Subject: Agency Notice for SD2025-0002 / Quail Run Acres Heights

RE: Preliminary Plat Approval for Quail Run Acres Subdivision
Case Number: SD2025-0002
Applicant: Ag Land & Development LLC
Property Owner: Infinite Real Estates Group
Planner: Daniel Lister

RE: HD4 Board of Commissioners
Pheasant Heights Subdivision
Preliminary Plat—Amended

Staff reviewed the preliminary plat for Pheasant Heights Subdivision. Plans reviewed were signed by Teller Bard, P.E. with stamp date 3/3/2026 and consists of 5 pages.

PHEASANT HEIGHTS SUBDIVISION
PRELIMINARY GRADING & DRAINAGE PLAN
CANYON COUNTY, ID

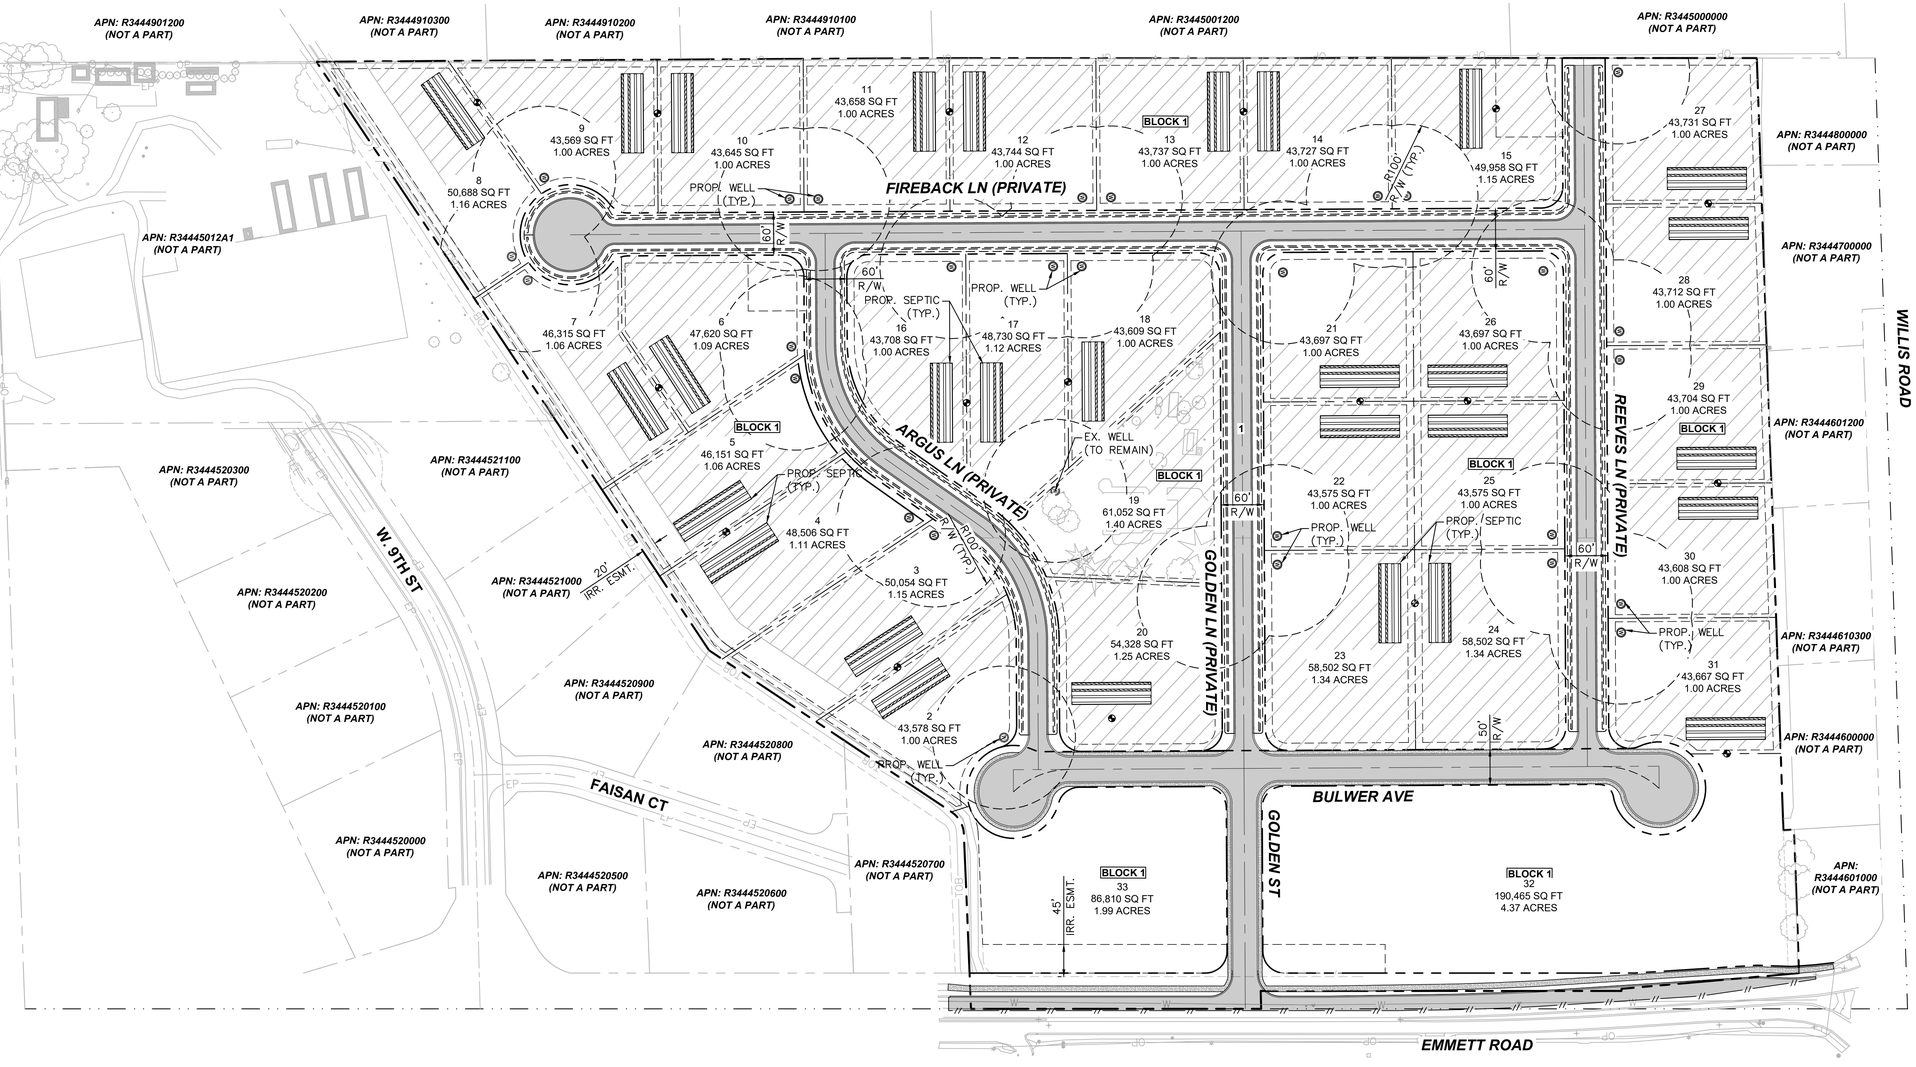
1. **No mention** of stormwater retention ponds or regional detention facilities — this needs to be clarified. If infiltration is the only method, soil permeability and backup capacity should be evaluated.
2. The developer should provide **long- and short-term stormwater protection plans** (especially during construction).
3. Final plat should include **CC&R references** outlining stormwater facility maintenance responsibility.
4. **Add notes for minimum separation distances** between water/sewer lines and other utilities, and between water lines and stormwater ditches.
5. **Sheet 04 & 05:** Existing irrigation lines and ditches are not clearly delineated. There may be shared irrigation facilities for the adjacent farmland, but these aren't clearly noted.
6. No irrigation water delivery system (pressurized lines, pumps, boxes) is shown for the lots.
